ADMINISTRATIVE REPORT

Title: DAV 25-232424\C – 135 Roslyn Rd

Issue: For variances to allow for the construction of a new multi-family building.

FILE: DAV 25-232424\C
RELATED FILES: N/A
COMMUNITY: City Centre Committee
NEIGHBOURHOOD #: 1.117 - (ROSLYN)

1 **SITE PLAN - NEW WORK**
 A1.2
 3/32" = 1'-0"

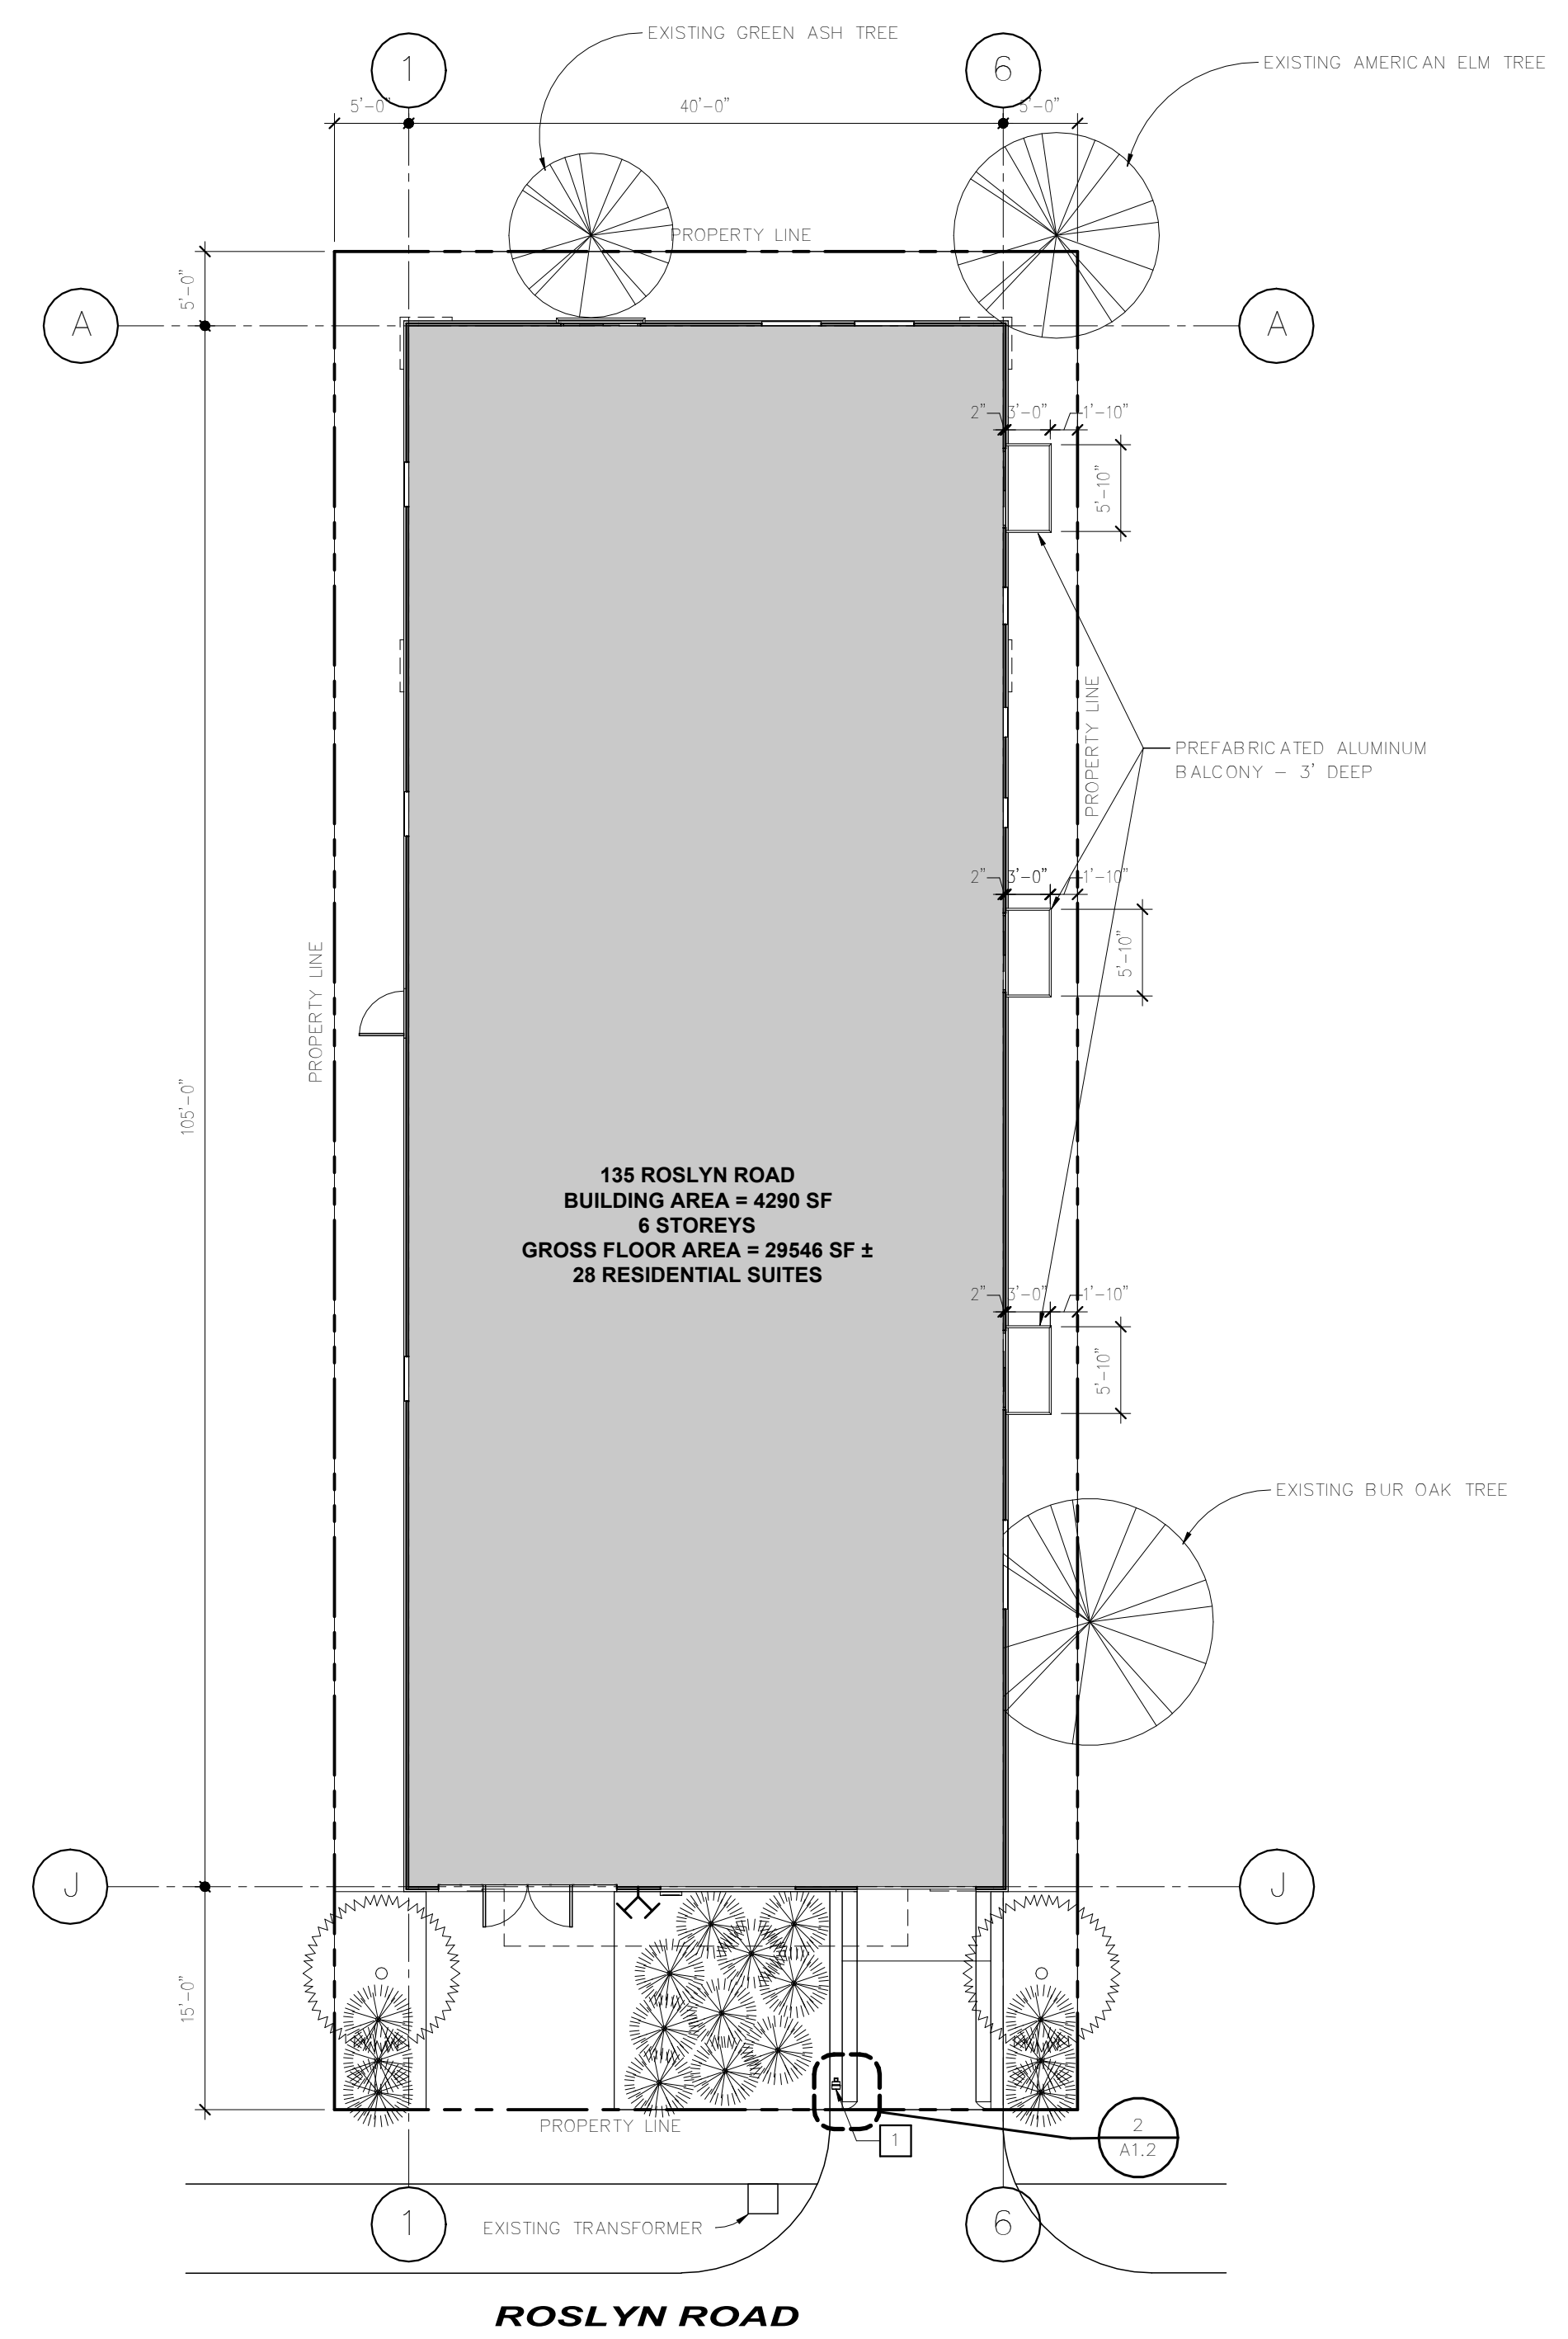
- 15' rather than the required 32' is a significant reduction to the front yard. However, a 15' front yard will allow the building to be brought closer to the street edge and make additional use of an "RMF-L" lot in a Village High Density Residential policy area that supports higher density residential development. Given the relatively small size of the lot, a reduction to the front yard enables high density development here.
- A 15' front yard also leaves ample space for the planting of front yard trees and it enables enough space to protect boulevard trees, should they be planted in future.

- The lot exists in a "Village High Density" policy area of the Osborne Village Neighbourhood Plan, which encourages high density development. Further, the lot is already zoned "RMF-L," which enables buildings of significant density and scale. However, the lot is relatively small by "RMF-L" standards, being only 50' in width. Given the relatively small lot width, it would be challenging to develop a high density, multi-storey building here if adherence to the side yard setbacks was required. For this reason, side yard reductions are necessary to meet the intent of the applicable secondary plan. While 5' setbacks are relatively small, their impact is mitigated by the fact that to the west is the parking area of a taller eight-storey building, and to the east is the blank wall of a gas station.

- Similar logic as applied to the side yards applies to the rear yard. That is, the lot exists in a "Village High Density" policy area of the *Osborne Village Neighbourhood Plan*, which encourages high density development, and the lot is already zoned "RMF-L." This presumes that the lot is intended for higher density residential development at a multi-family scale. However, enabling that higher density development on a relatively small lot requires reductions to the yards – including the rear yard – to accommodate the expected density.
- The rear yard abuts the parking area of another multi-family development, with the actual living component being approximately 200' from the property line. For this reason, the

reduced rear yard does not have a substantial adverse effect on the residential portion of the abutting property to the north. However, there are two mature trees located on the abutting property near the shared property line. An arborist report was submitted with this application, and it indicates that the root structure of both those trees extends into the property limits of 135 Roslyn Road (the subject site). By enabling a reduced rear yard here, the two mature trees will be impacted and are likely to die eventually. This is unquestionably an adverse effect on the amenities of the neighbouring property. Consideration was given as to whether the new building should be moved closer to the front property line to avoid damaging the root structure of the existing trees. Ultimately, it was determined that this was not an appropriate solution for the following reasons:

- First, the trees are located very near the shared property line, which means their retention would likely constrain most future development scenarios on 135 Roslyn Road. This is particularly important given that 135 Roslyn Road is zoned “RMF-L”, which anticipates higher-intensity development on a relatively small parcel.

- Second, preserving the trees would require the proposed building to be shifted approximately 10’ farther from the rear property line. This change would have significant design implications. Moving the building south would substantially increase the slope of the ramp providing access to the underground parking, likely beyond what is feasible. Alternatively, removing 10’ of buildable area at the rear of the site would reduce the overall developable footprint. Given the lot’s limited size, its “RMF-L” zoning, and its location within a High Density policy area of the *Osborne Village Neighbourhood Plan*, this reduction would run counter to both zoning and policy objectives that encourage higher-intensity development on this lot.

- Lastly, the Urban Planning and Design Division seeks to retain mature trees wherever possible during infill development. However, infill projects often affect existing vegetation due to changes in building form and site layout. While this outcome is unfortunate, it is not uncommon. If the lot were larger, if a rezoning to “RMF-L” were being proposed, or if the site were not within a high-density policy area, greater weight could be given to preserving the trees adjacent to the rear yard. In this case, those conditions are not present.

- The driveway is signal-controlled, meaning that in practice only one vehicle will use the driveway at a time. For this reason, a reduced driveway width is not an issue. Further, it enables a narrower access through the public boulevard, preserving green space.
- The majority of the drive aisle is 20'. Given that the overall parking area is relatively short, it is expected that vehicles travelling in opposite directions will be able to see each other and wait in the wider part of the aisle if they encounter each other at the narrowest point of the aisle. Furthermore, given that most of the aisle is 20' in width, there is ample space for vehicles to maneuver into their parking spaces.

- 1) for the construction of a multi family dwelling to permit:
 - a) a front yard of 15 feet (4.57 metres) instead of 32 feet (9.75 metres);
 - b) an east side yard of 5 feet (1.52 metres) instead of 18 feet (5.49 metres);
 - c) an east side yard balcony projection of 3 feet (0.91 metre) instead of 1.6 feet (0.49 metre);
 - d) a west side yard of 5 feet (1.52 metres) instead of 18 feet (5.49 metres);
 - e) a rear yard of 5 feet (1.52 metres) instead of 25 feet (7.62 metres);
 - f) a lot area per dwelling unit of 223 square feet (20.72 square metres) instead of 400 square feet (37.16 square metres);
 - g) 7 parking spaces instead of 16 spaces;
- 2) for the establishment of accessory parking to permit:
 - a) 3 small car parking spaces instead of 2 small car parking spaces;
 - b) a driveway of 10 feet (3.05 metres) instead of 16 feet (4.88 metres);

1. That, if any variance granted by this order is not established within two (2) years of the date hereof, this order, in respect of that Variance shall terminate.
2. That the development shall be constructed in substantial conformance with the plans attached and identified as Sheets 1-11 for File No. DAV 25- 232424\C, and thereafter maintained to the satisfaction of the Director of Planning, Property and Development;
